ADDENDUM
NO. 3

July 31, 2020

Additions & Renovations to Lawrence North High School
7802 Hague Road
Indianapolis, IN 46256

PREPARED BY SCHMIDT ASSOCIATES FOR:
LAWRENCE NORTH HIGH SCHOOL RENOVATION
LAWRENCE TOWNSHIP, M.S.D. OF

J. **Drawing Number M-405**

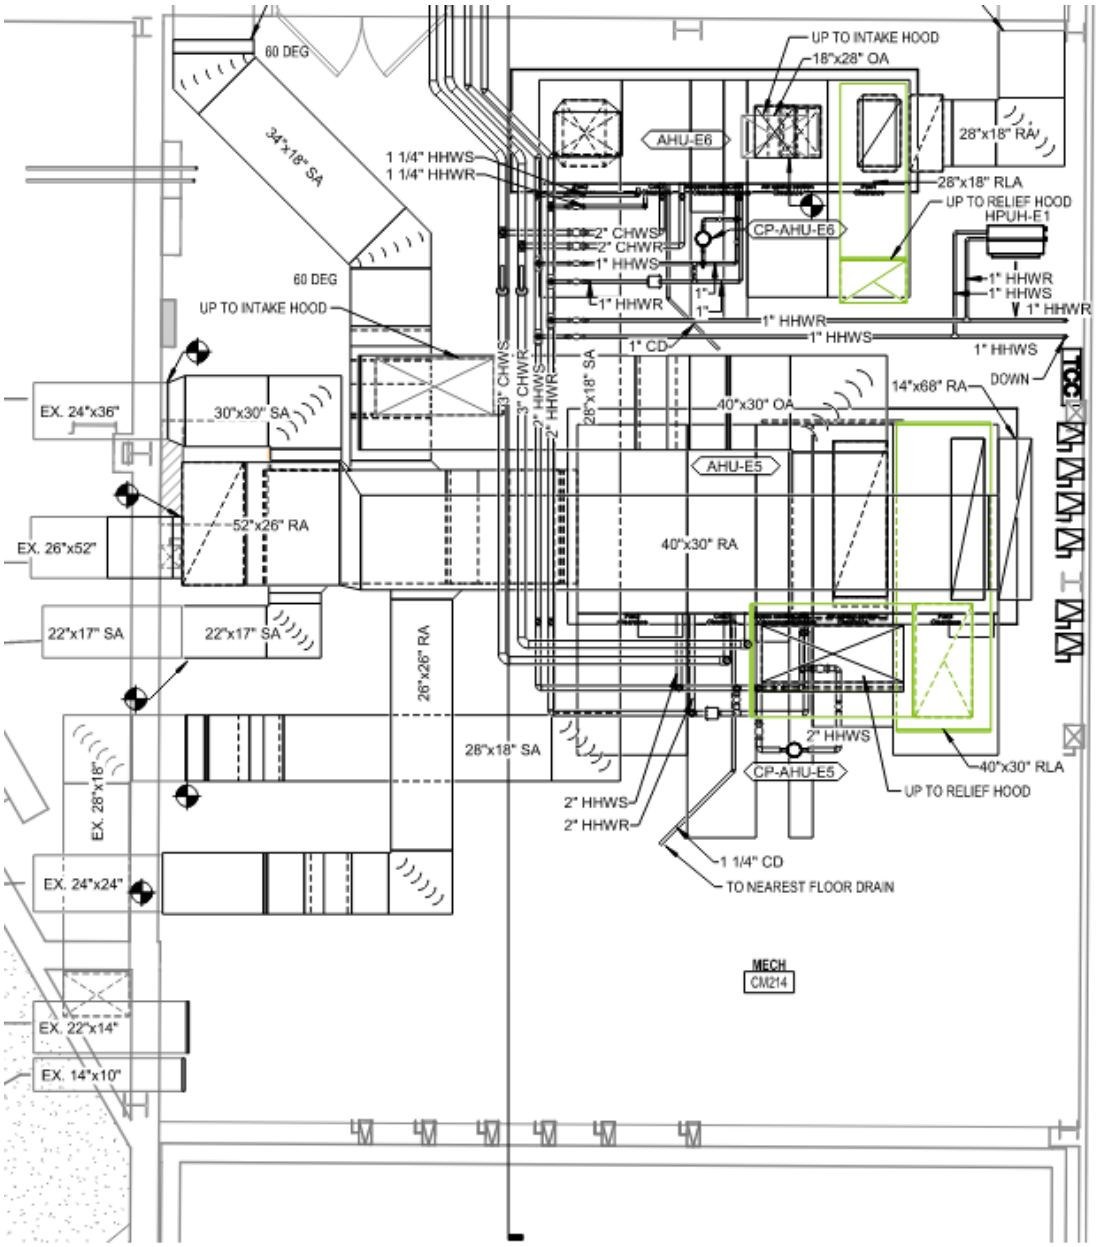
1. MODIFY Drawing as shown below: Modify intake and relief ductwork. Miscellaneous piping and duct sizes added.

K. **Drawing Number M-406**

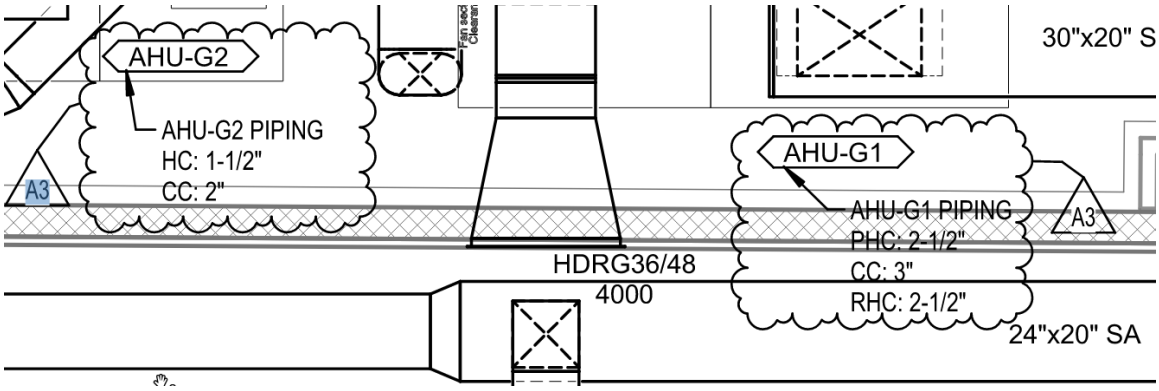
1. MODIFY Drawing as shown below: Piping sizes defined.

L. **Drawing Number M-404**

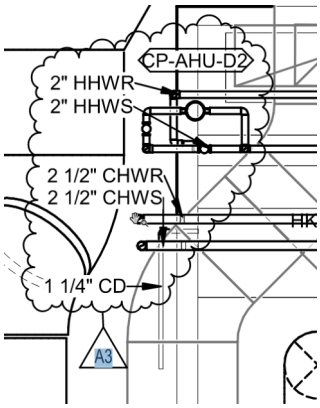
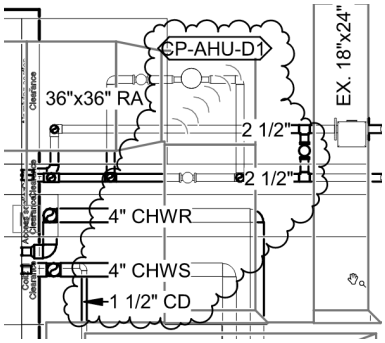
a. AHU-D2 piping sizes defined.

b. AHU-D1 piping sizes defined.

M. **Drawing Number M-407**

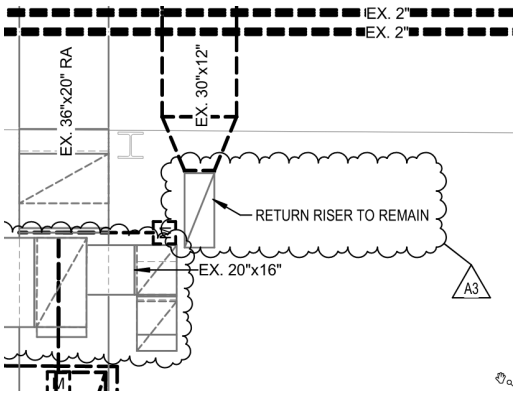
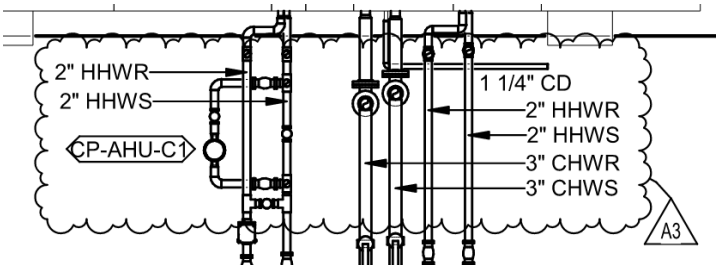
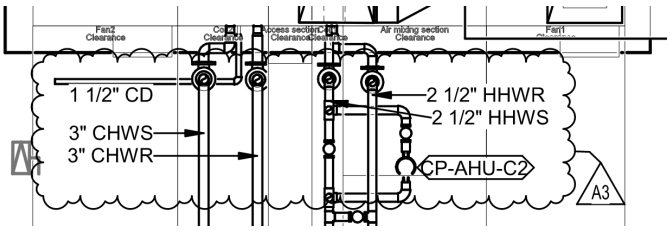
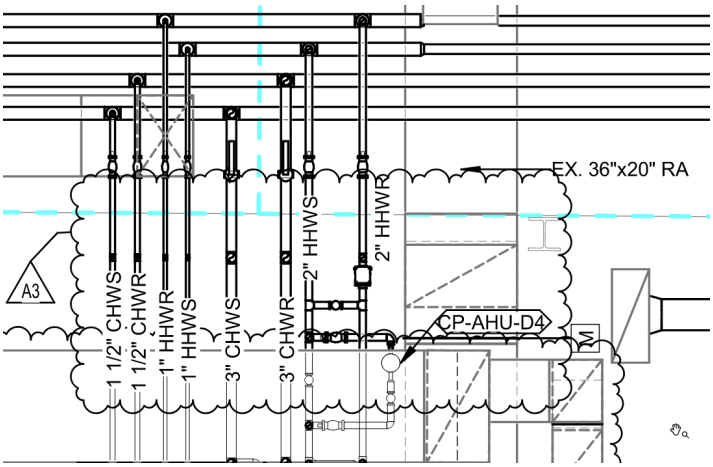
a. Demo view: Changed return riser to remain.

b. New work view: Pipe sizes serving AHUs defined.

P. **Drawing Number MDP1H2**

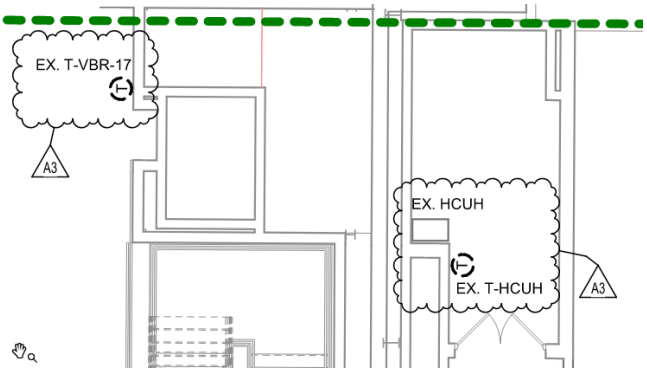
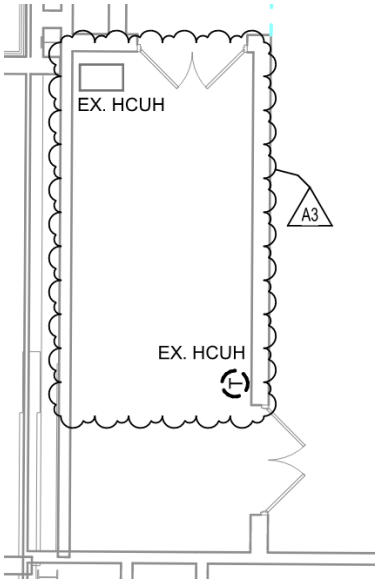
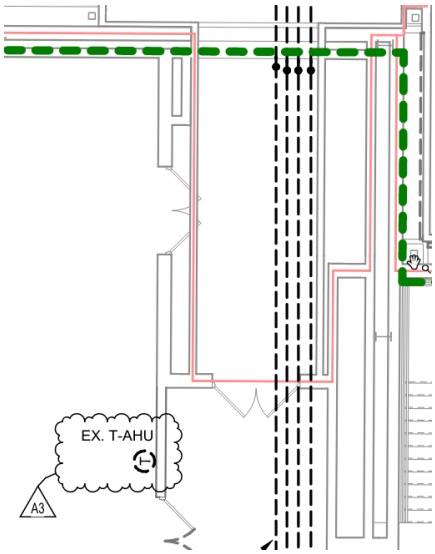
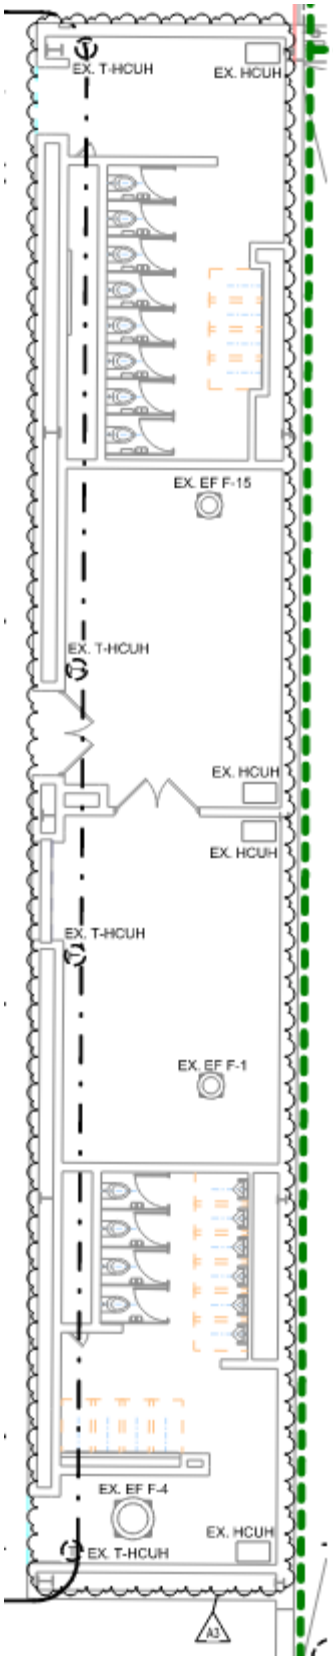
1. MODIFY Drawing as shown below: Showing existing HCUH and Tstat/Tsensor replacements.

Q. **Drawing Number MP1G2**

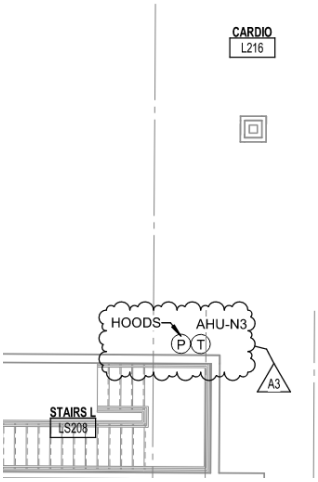
1. MODIFY Drawing as shown below: Showing replacement of Tstat and Pstat.

R. **Drawing Number MP1H2**

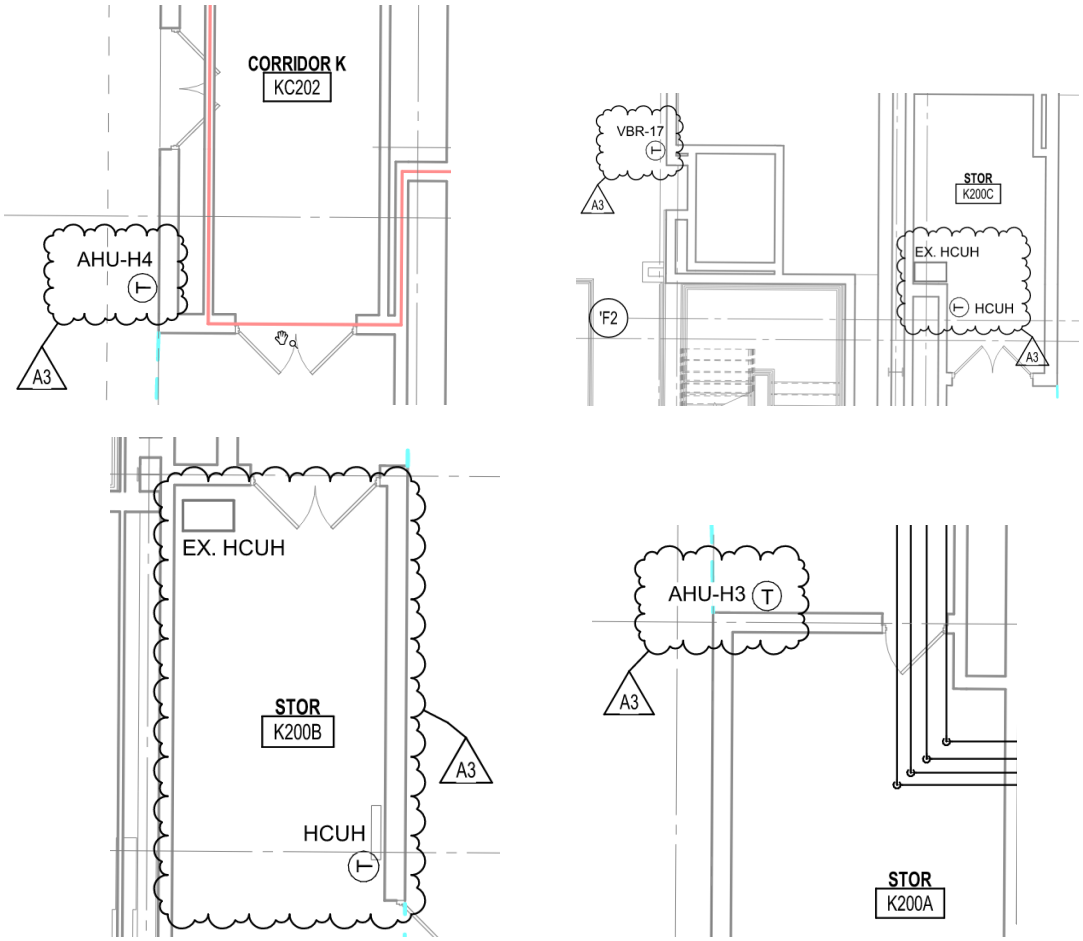
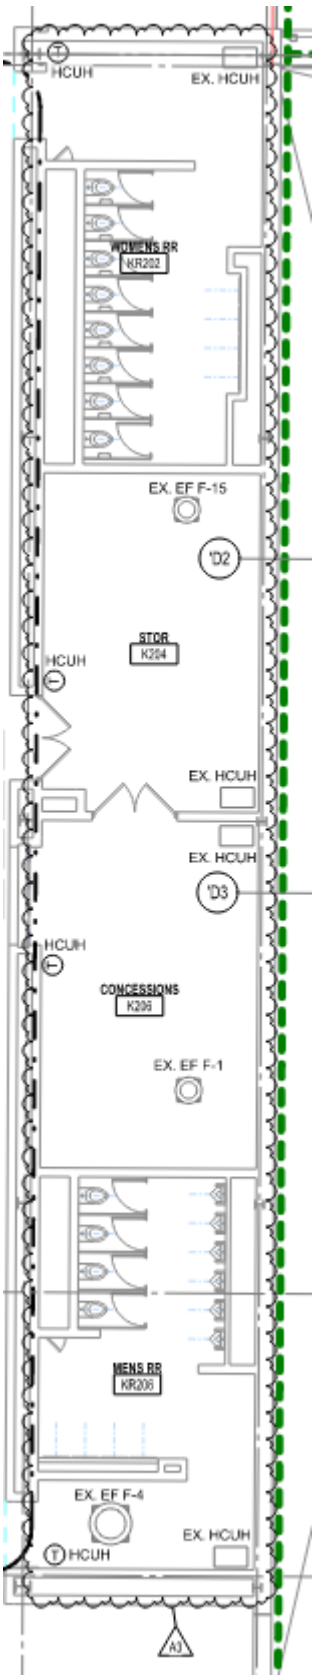
1. MODIFY Drawing as shown below: Showing replacement of Tstats.

S. **Drawing Number MP1F2**

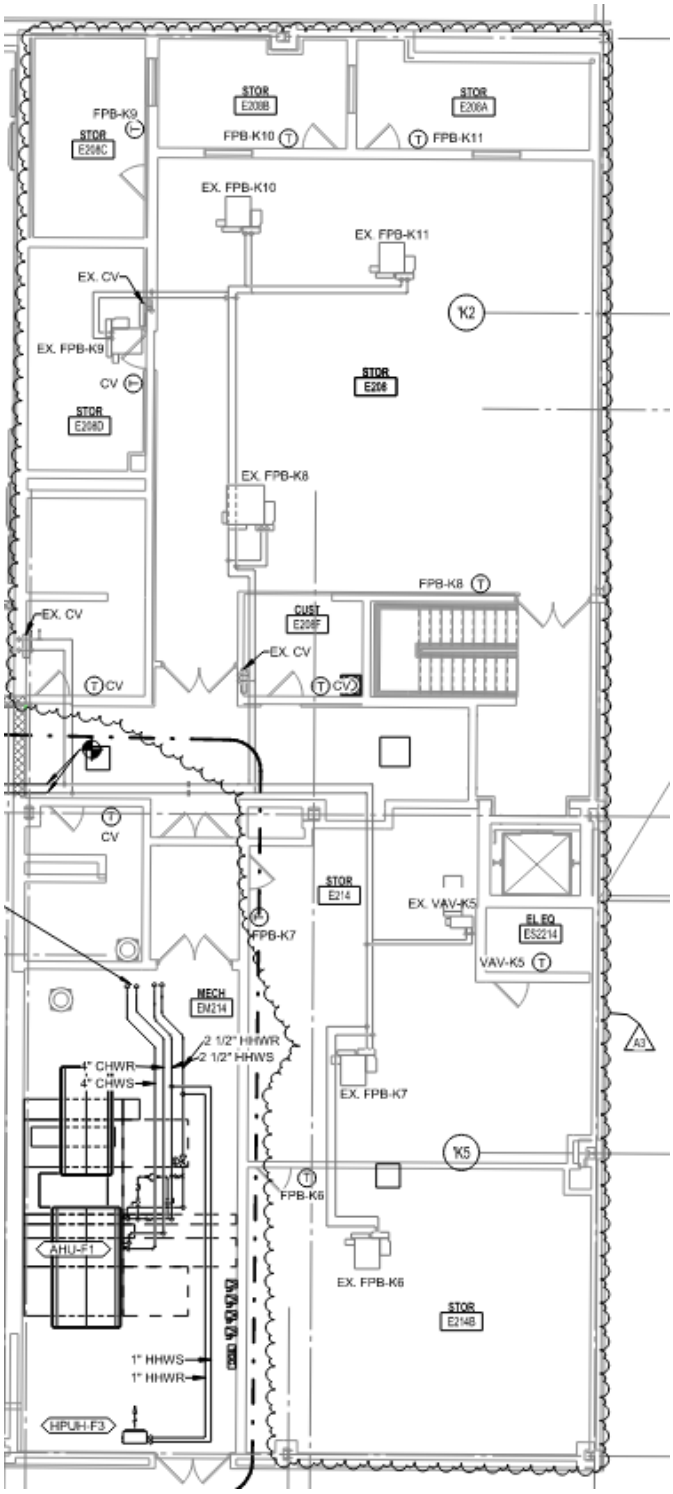
1. MODIFY Drawing as follows: DELETE text note and branch piping above practice room. Delete note "2-1/2 HHWS & HHWR DN. SEE SHEET MP1F1 FOR CONT."

2. MODIFY Drawing as follows: Showing replacement of Tstats.

V. **Drawing Number MP1G1**

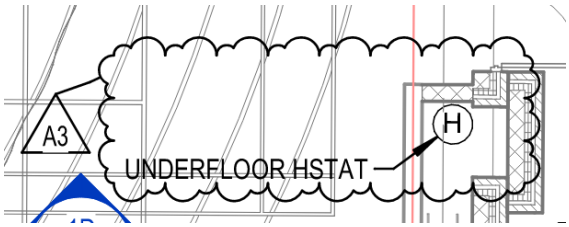
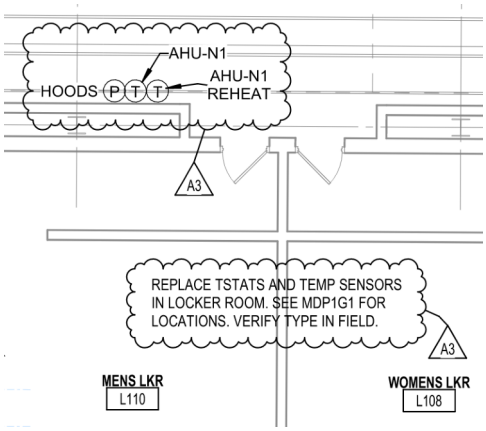
a. Add replacement of two underfloor Hstats.

b. Clarify Tstat and Psensor replacements in fieldhouse and locker room areas.

X. **Drawing Number MP1F1**

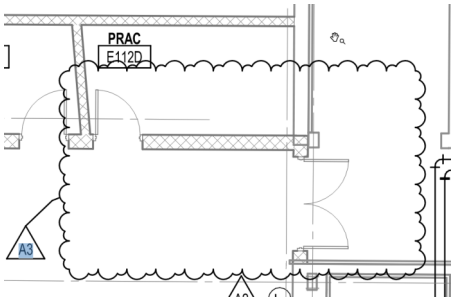
b. Remove piping scope as shown below:

Y. **Drawing Number MDP1G1**

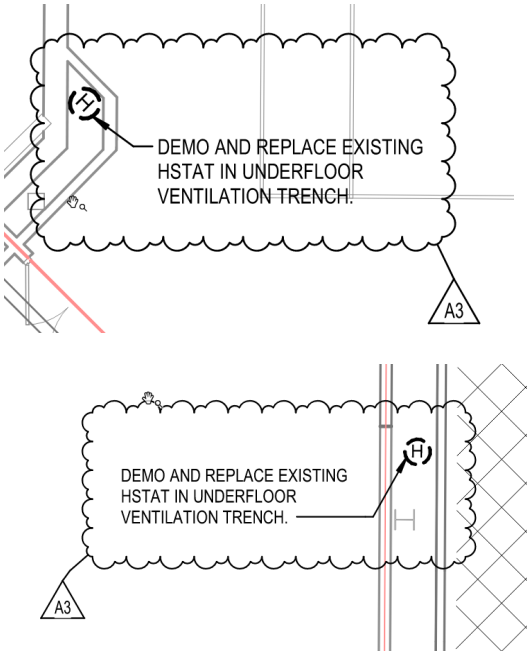
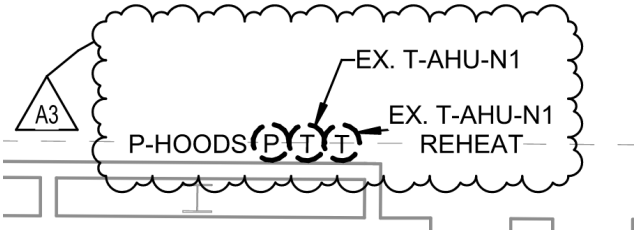
a. Add replacement of two underfloor Hstats, as shown below:

b. Clarify replacement of T and P sensors serving AHU-N1 and relief hoods, as shown below:

Z. **Drawing Number MH1H2**

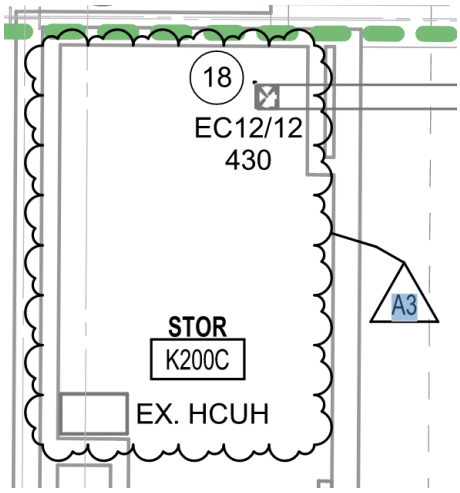
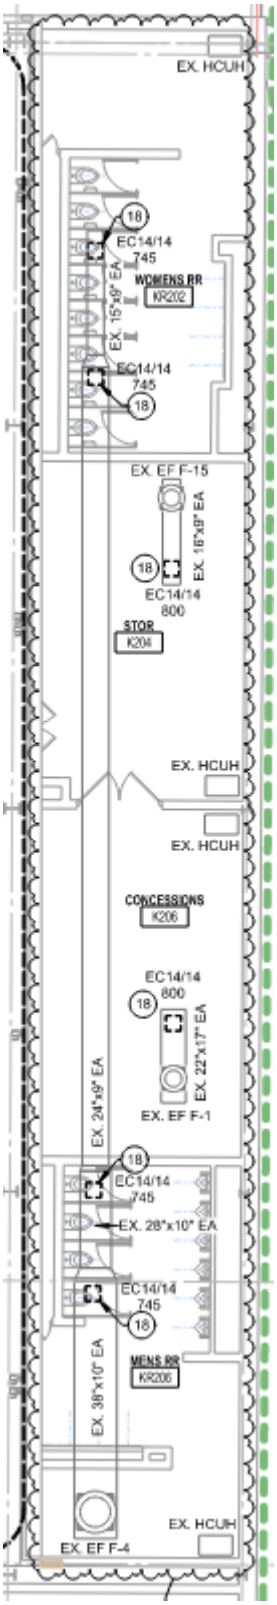
1. MODIFY Drawing as shown below: Show existing to remain equipment. Show grille replacements.

AA. **Drawing Number MH1G2**

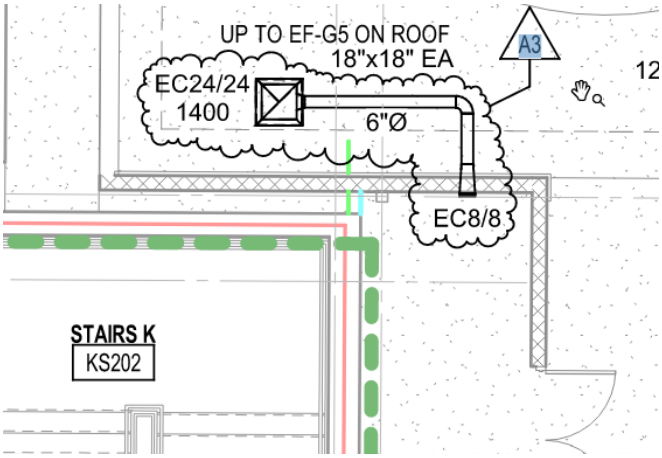
b. Add exhaust duct tapped into wrestling room custodial closet as shown below.

EE. **Drawing Number MR102**

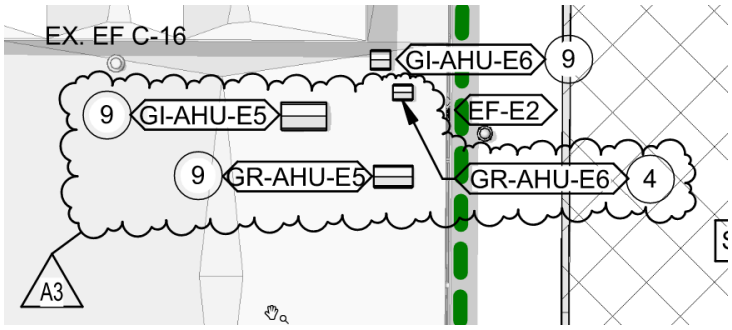
1. MODIFY Drawing as shown below: Showing GR-AHU-E6. Location for E5 hoods switched.

A. **Drawing Number PD1H0**

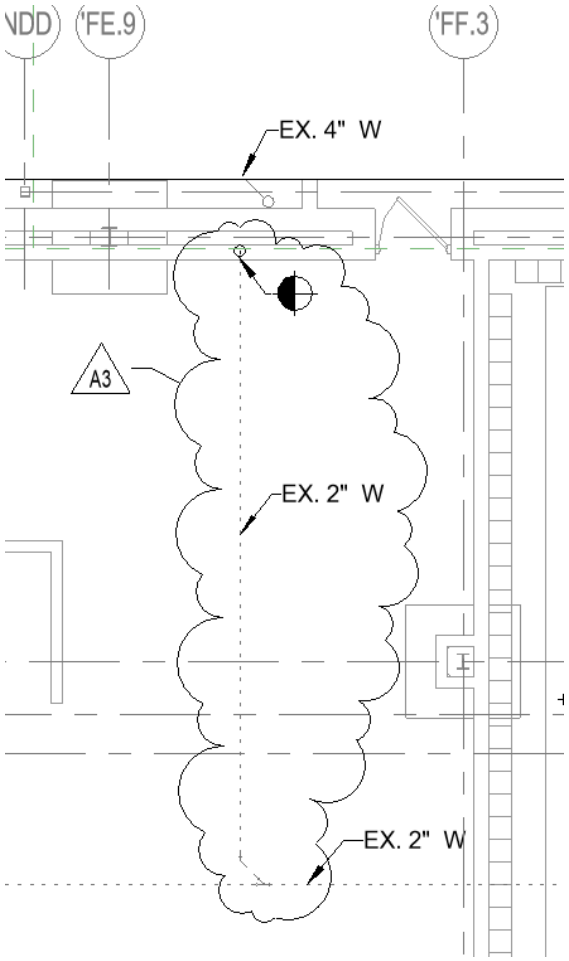
Abandon existing 2” waste piping in place.

B. **Drawing Number PD1H1**

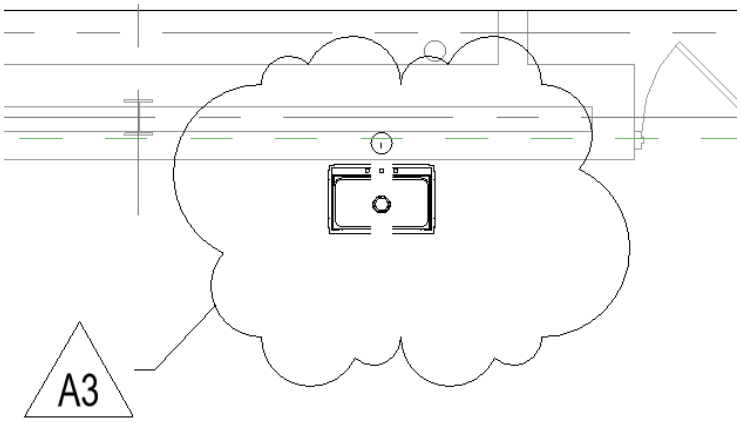
Remove existing sink and associated piping.

C. **Drawing Number PF1E0**

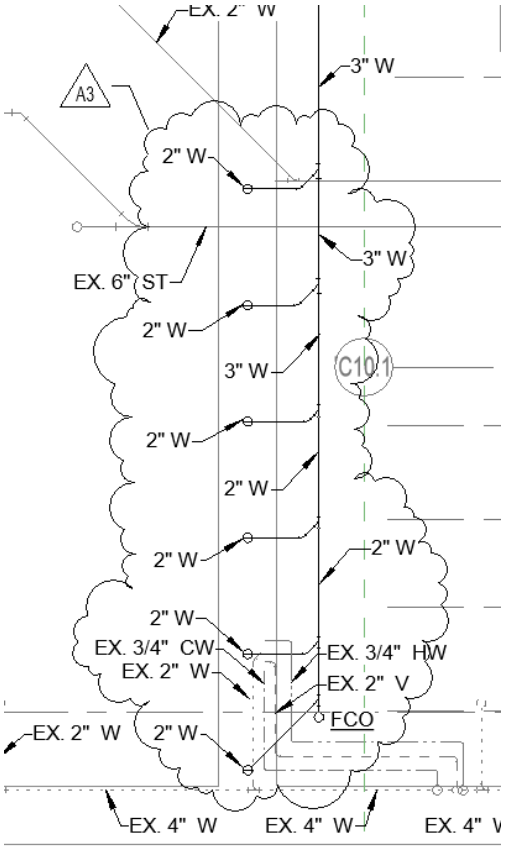
Modify underground waste piping to Lav's.

D. **Drawing Number PF1H0**

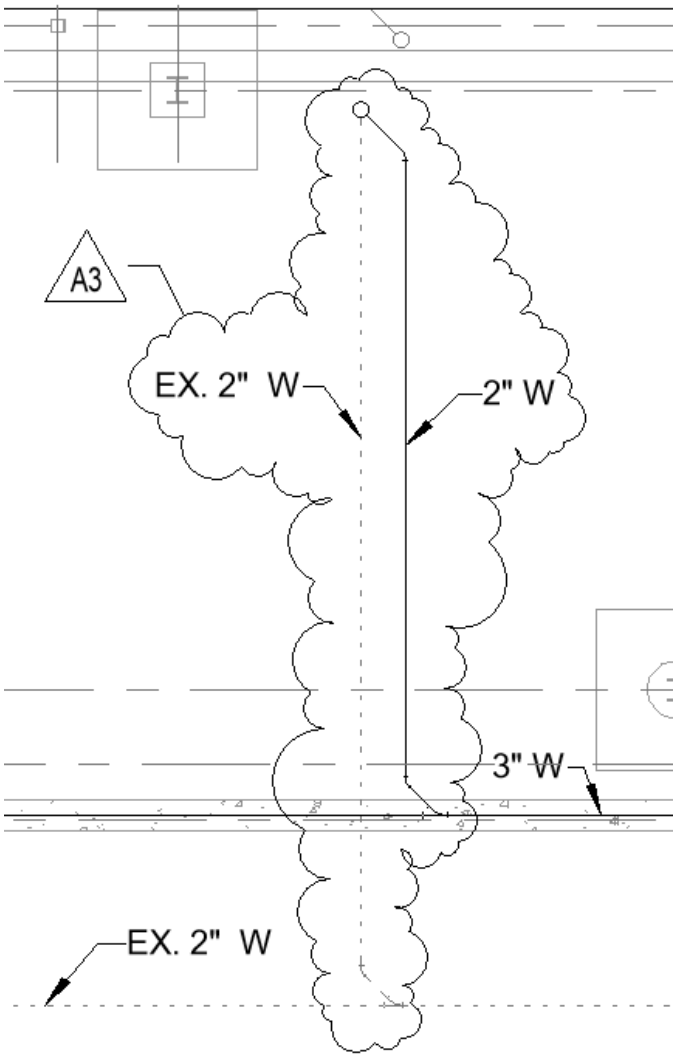
Add 2” underground waste piping for new sink.
